## **ADDENDUM #1**

### **WINGFIELD HILLS RD STORM DRAIN IMPROVEMENTS**

**BID #18/19-022**

**C-2**

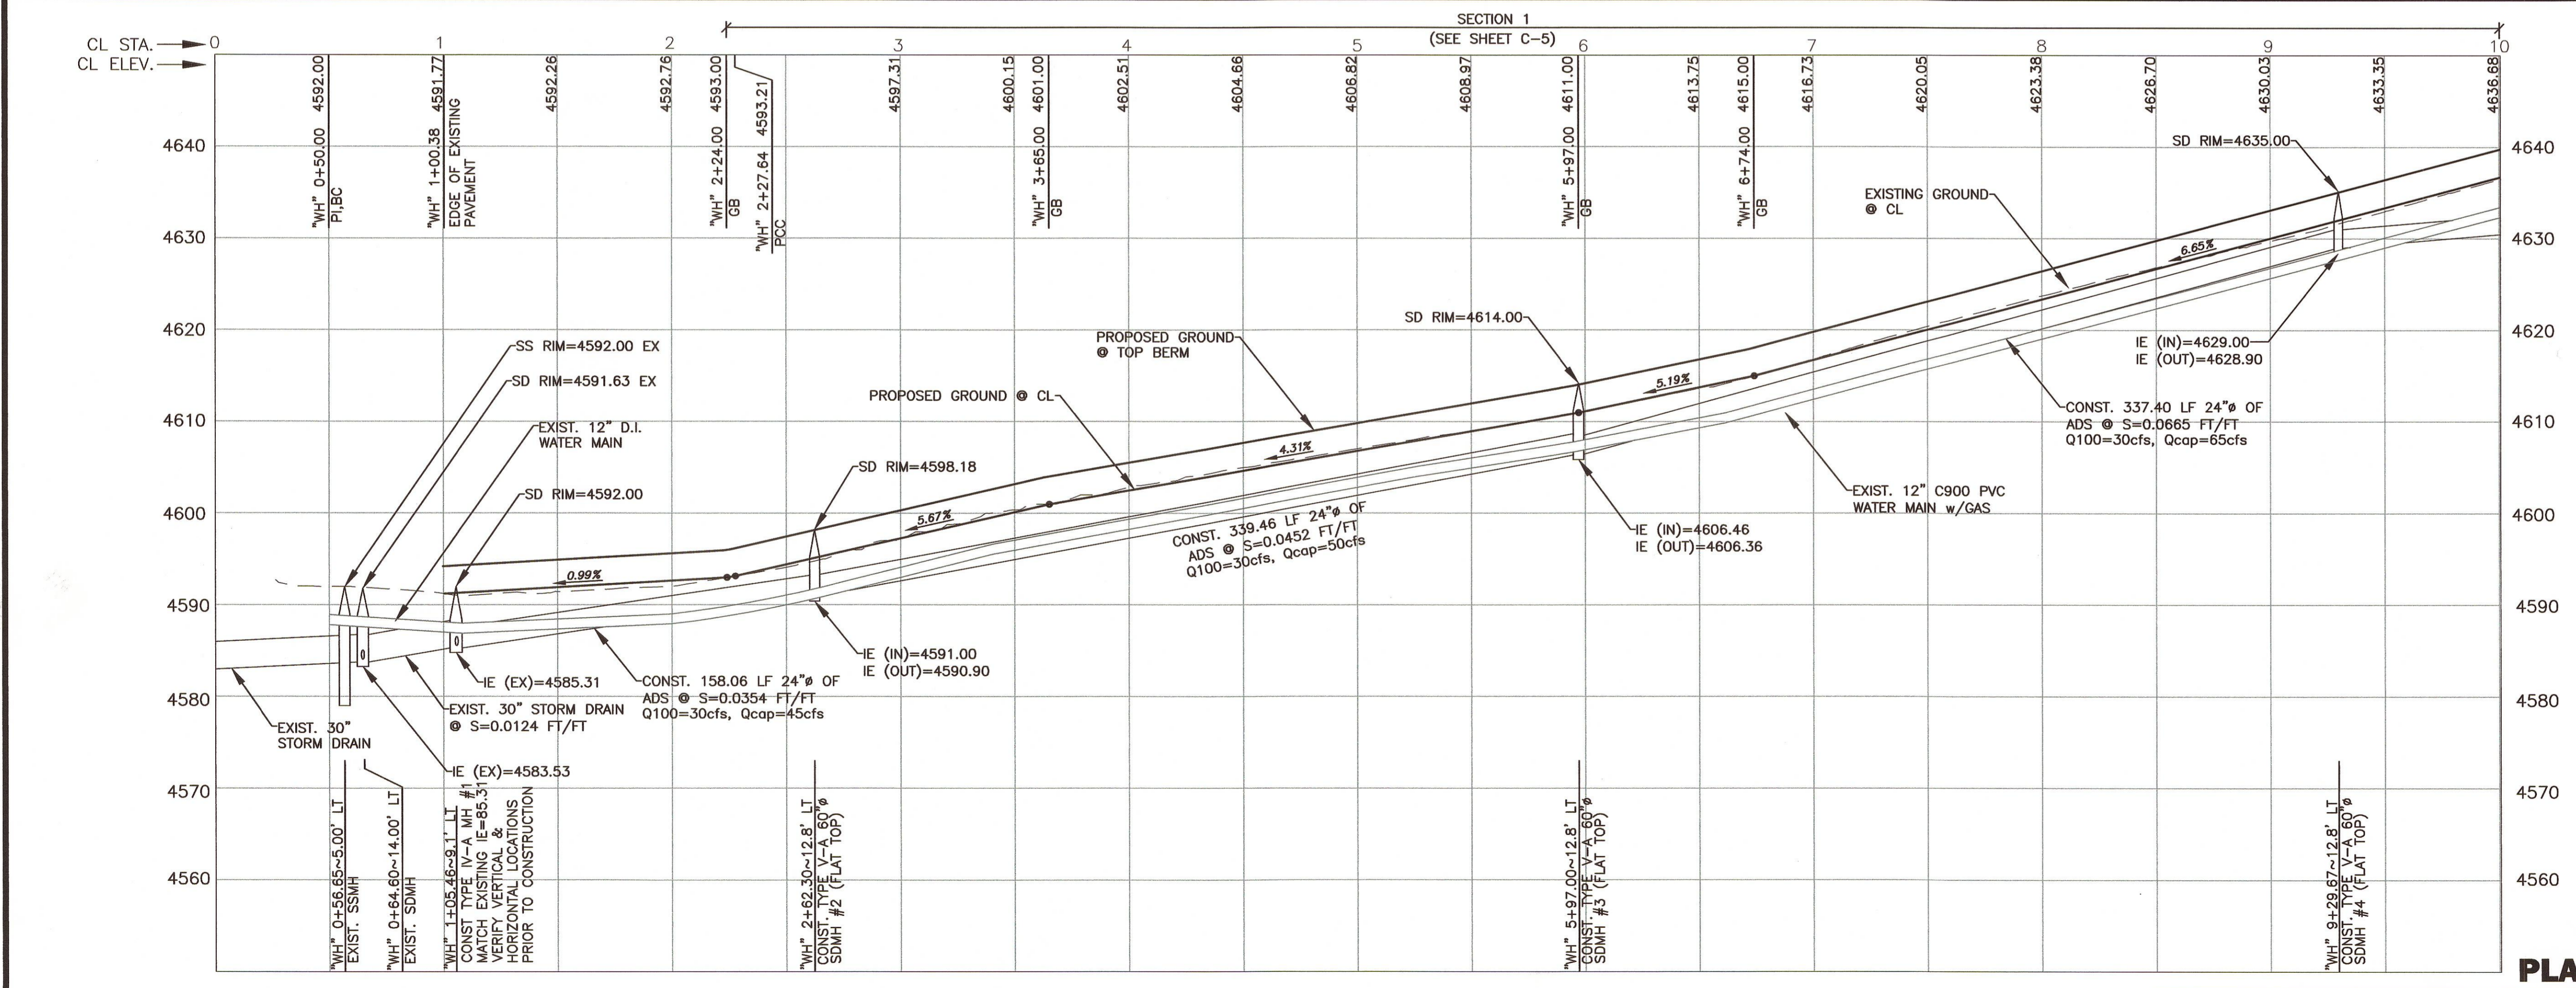
5/21/19 BID ADDENDUM #1  
REVISED POND GRADING DUE TO CONFLICT WITH SIDEWALK AND ELECTRICAL VAULT & PAD

**DETENTION POND GRADING PLAN**

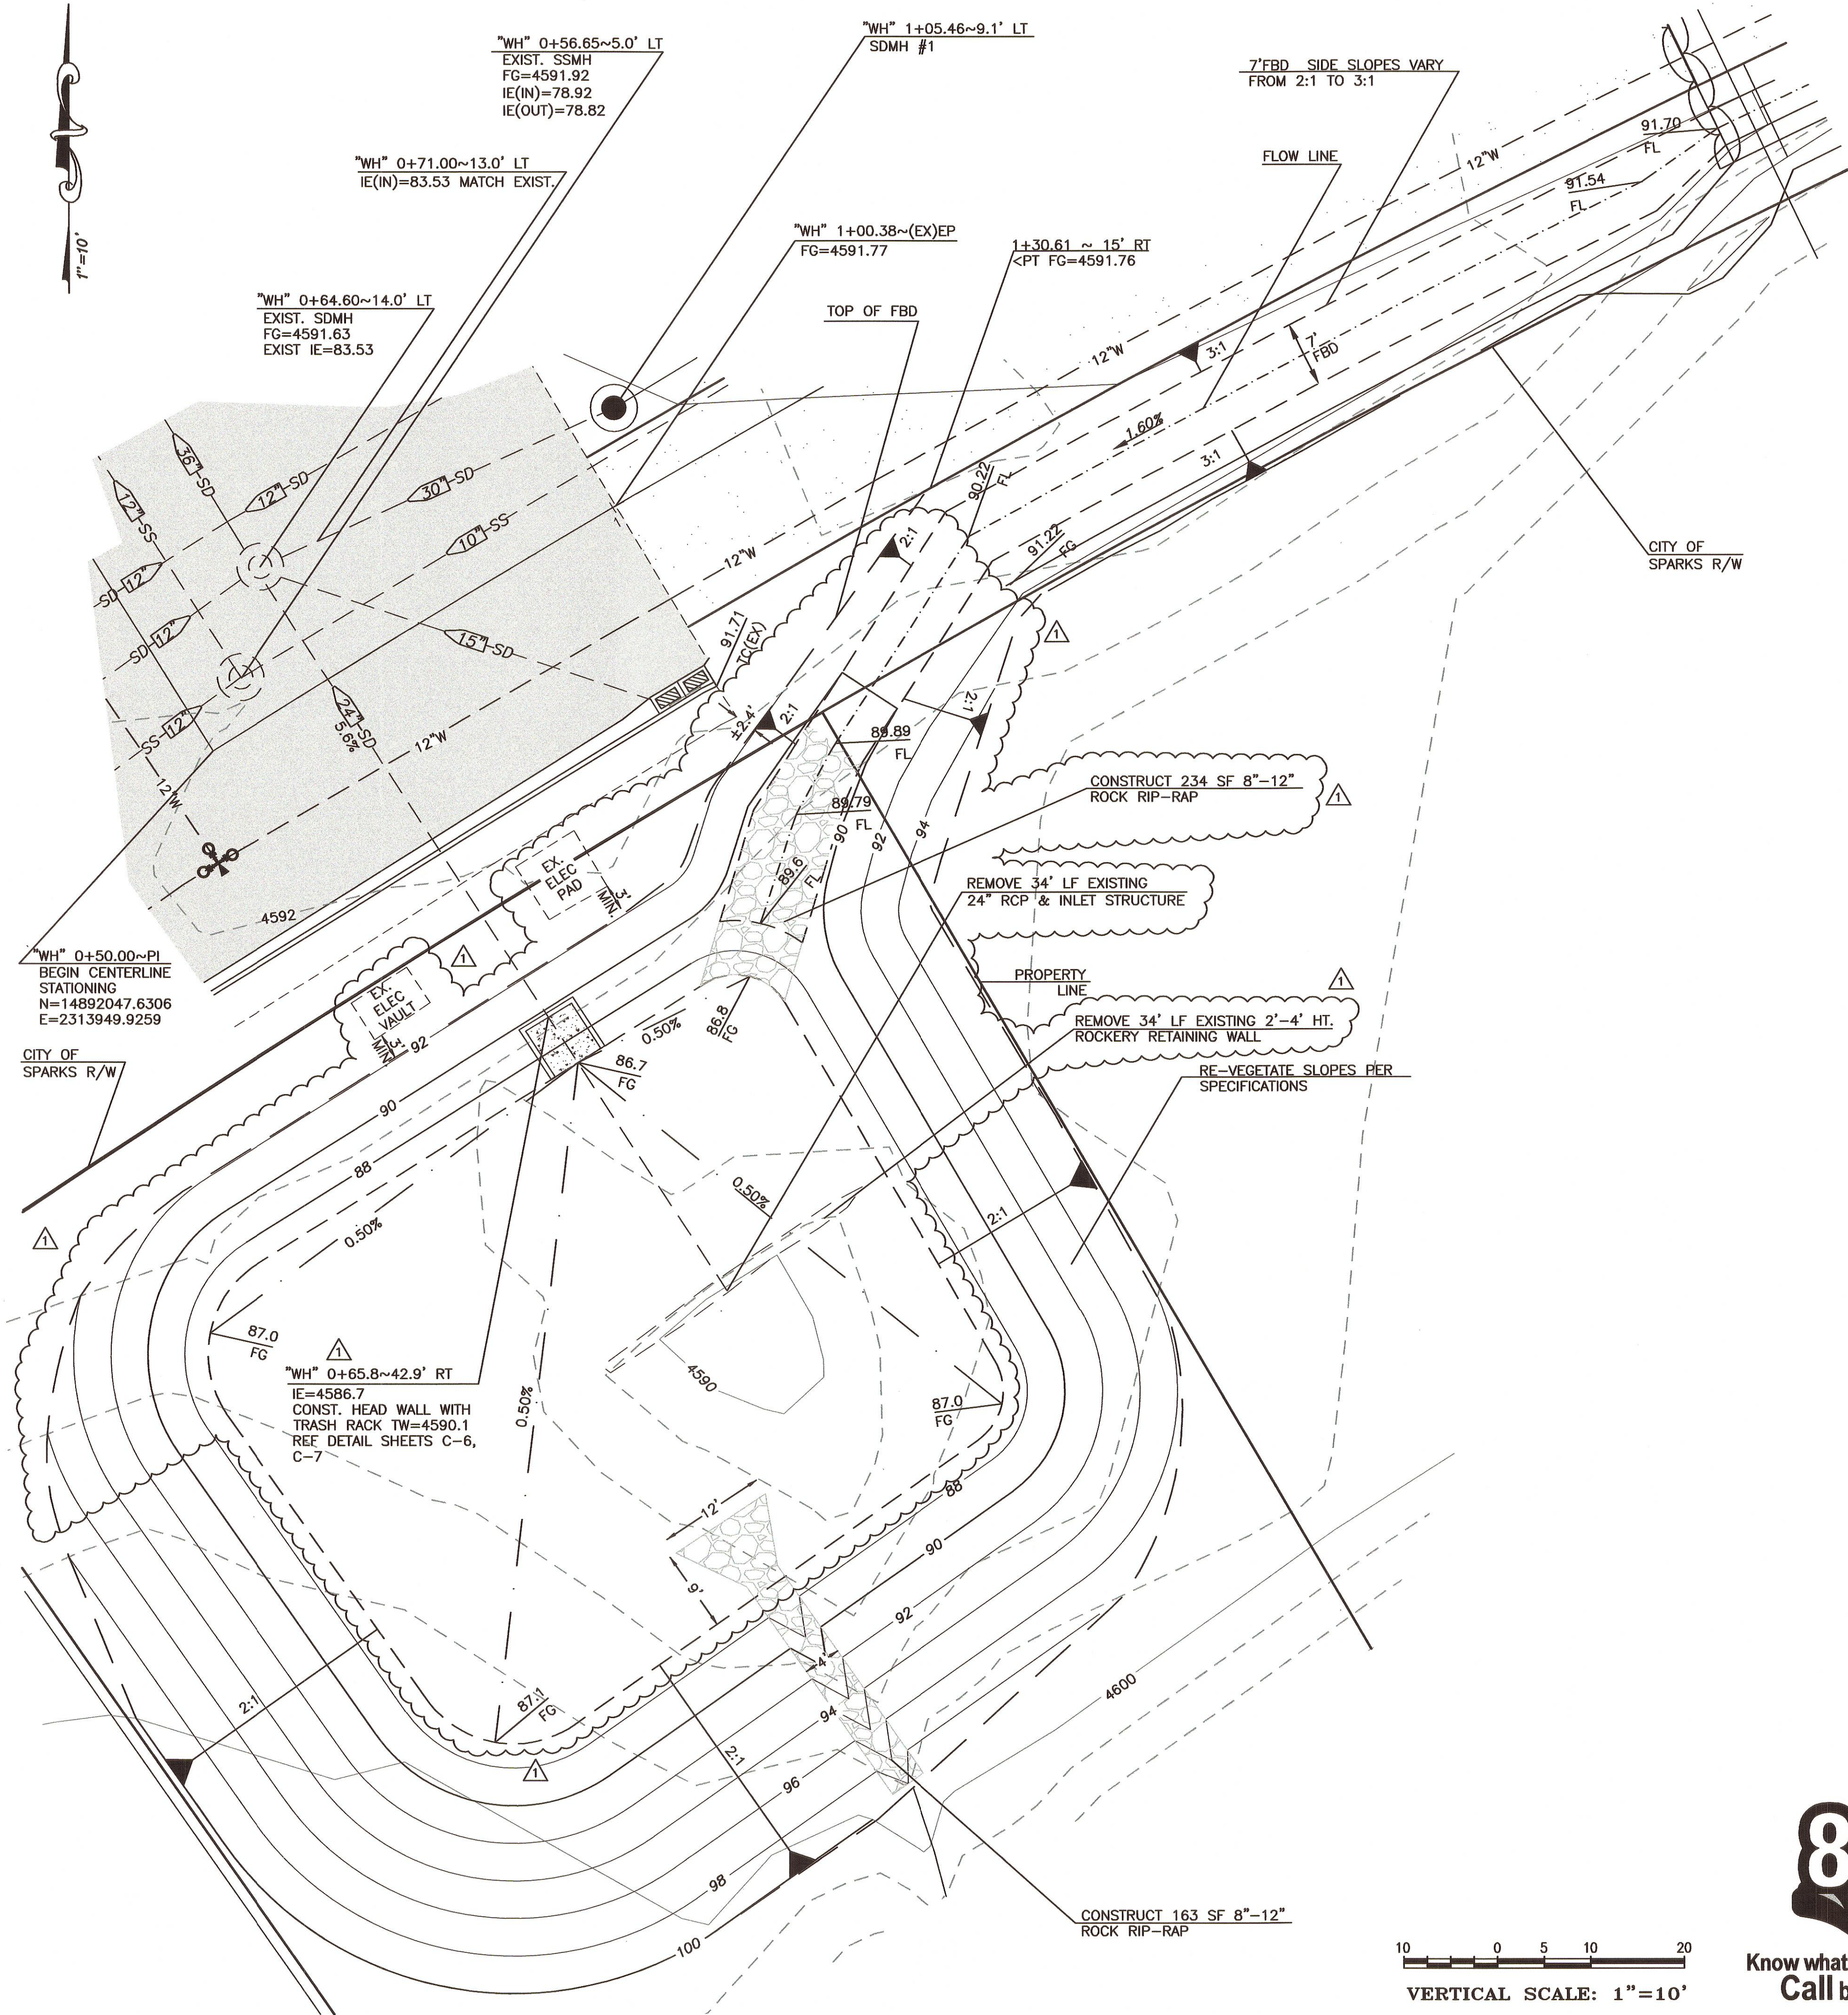
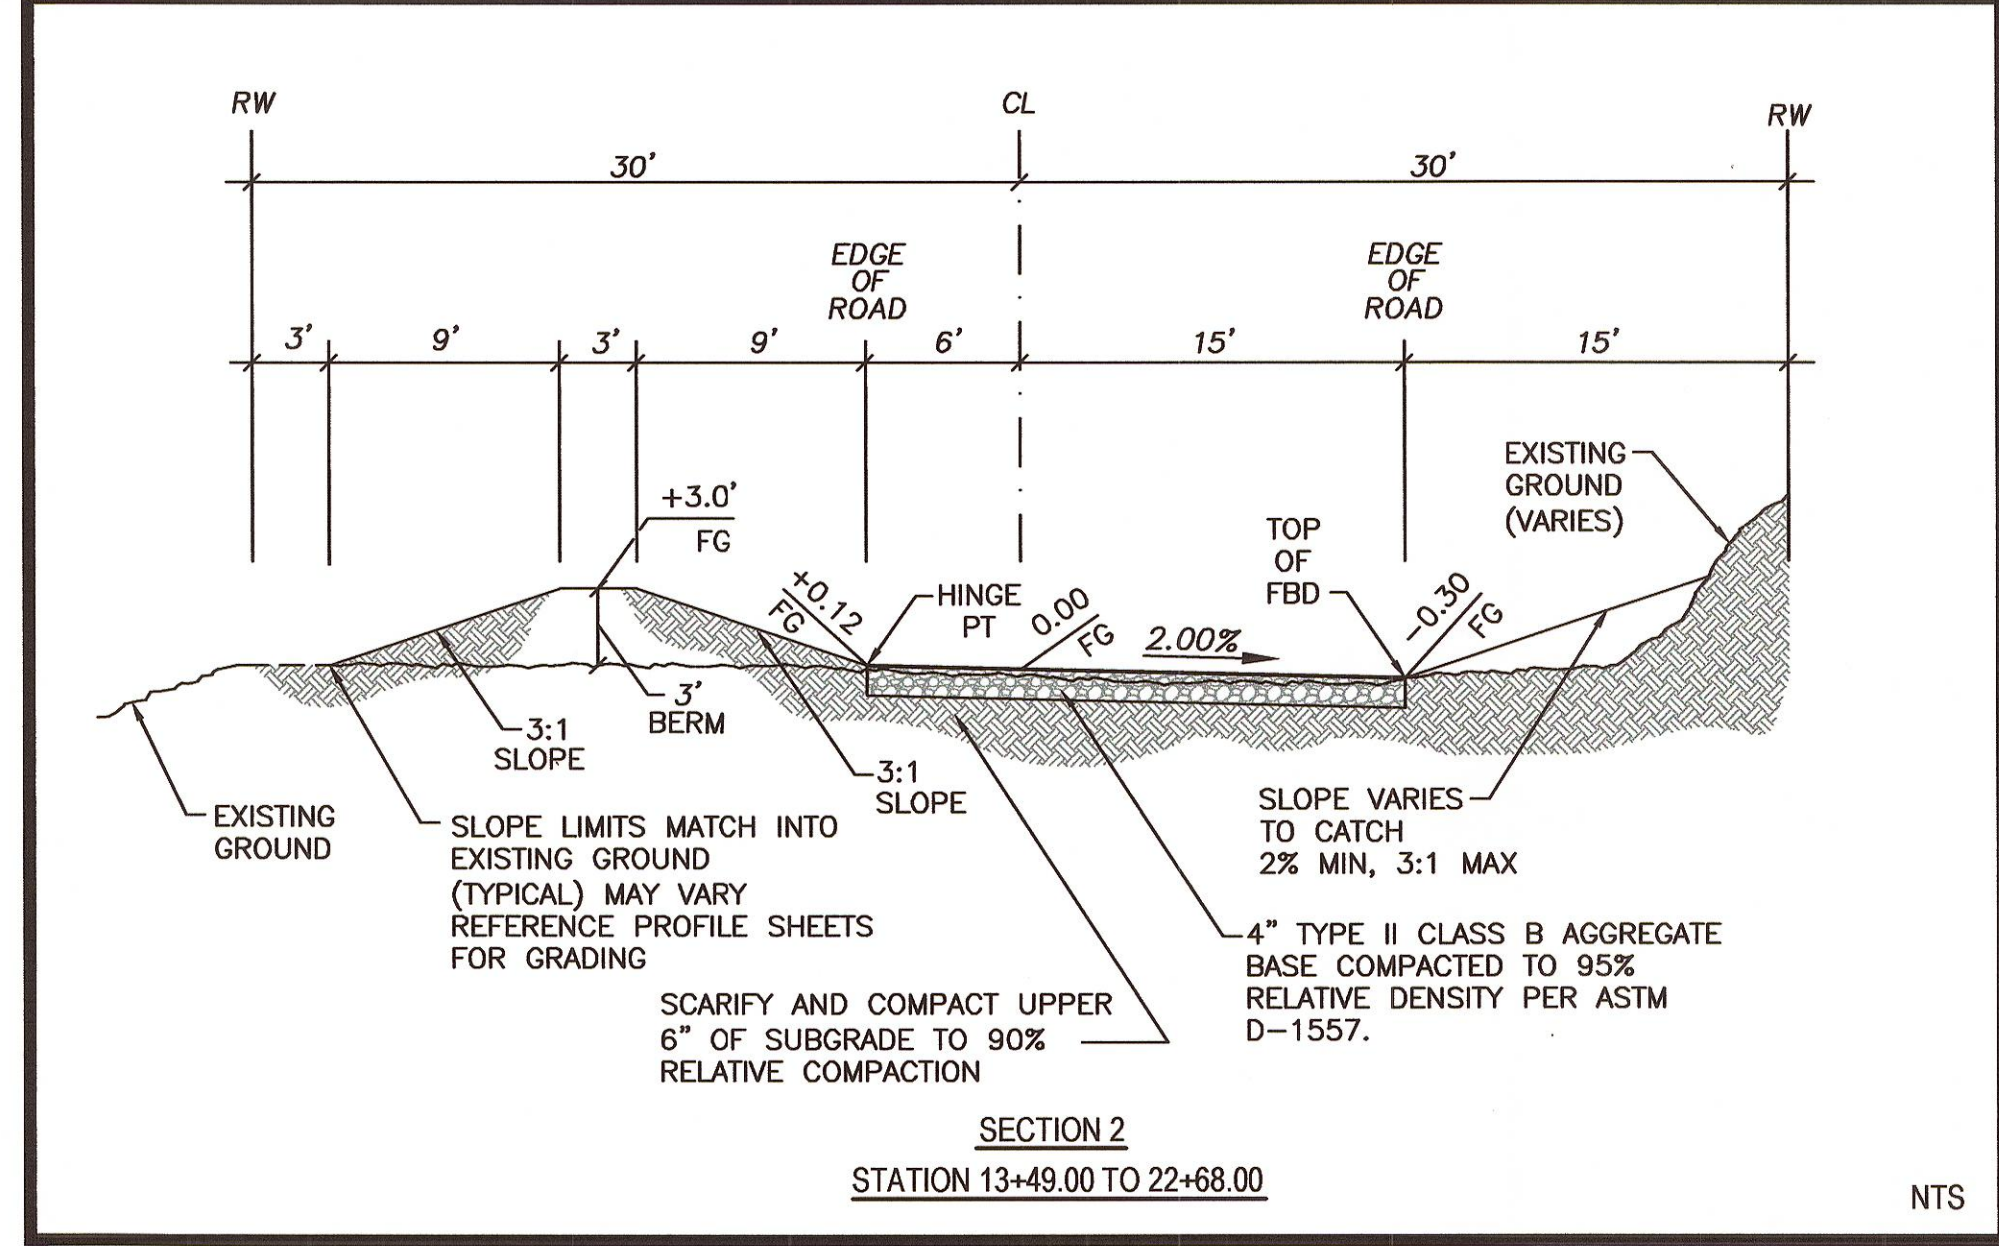
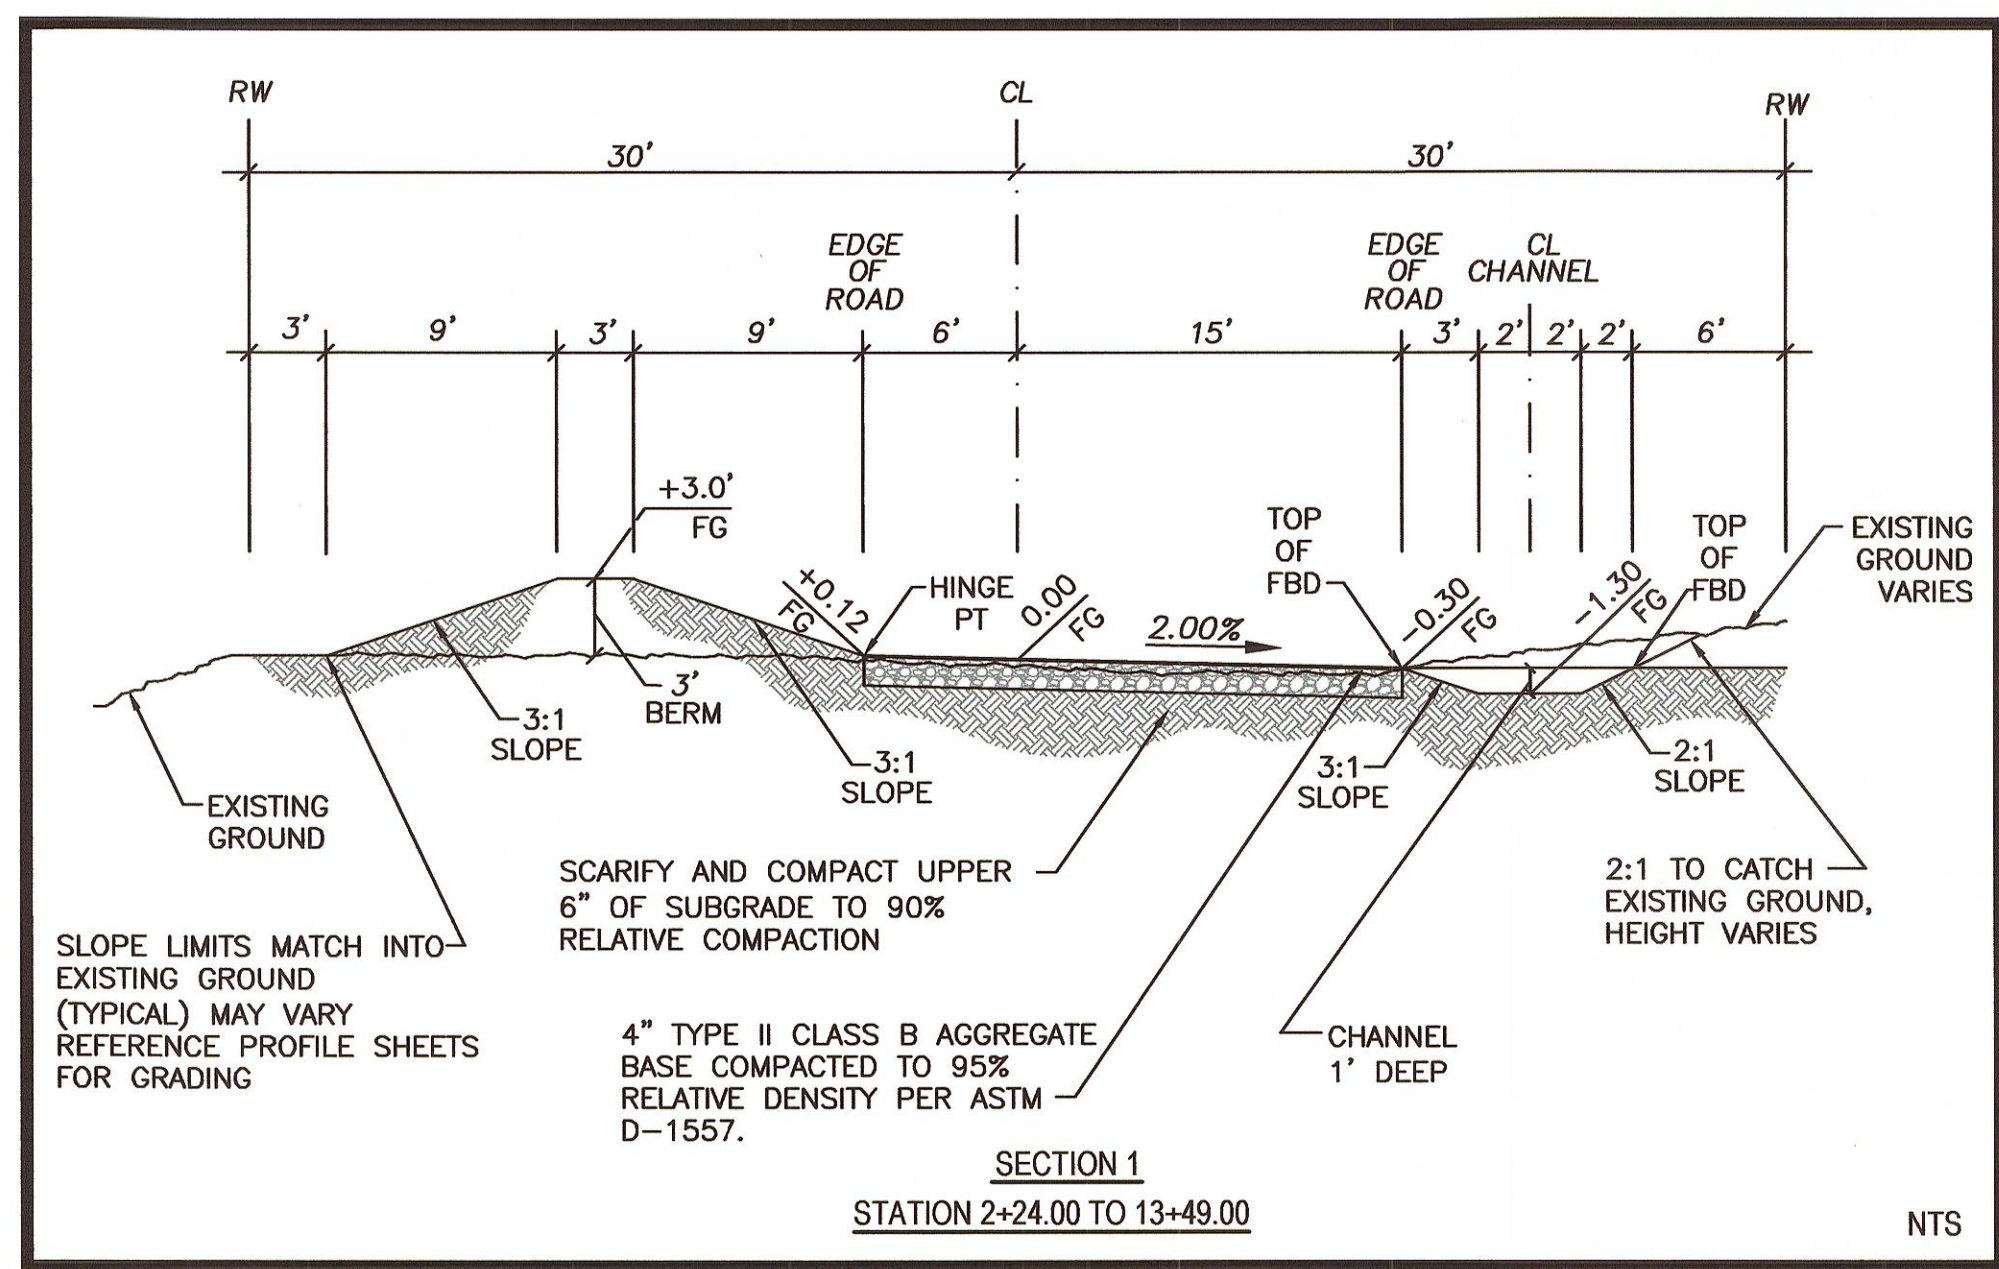
5/21/19 BID ADDENDUM #1  
 REVISED POND GRADING DUE TO CONFLICT WITH SIDEWALK AND ELECTRICAL VAULT & PAD, ADDED REMOVAL OF EXISTING ROCKERY WALL IN POND
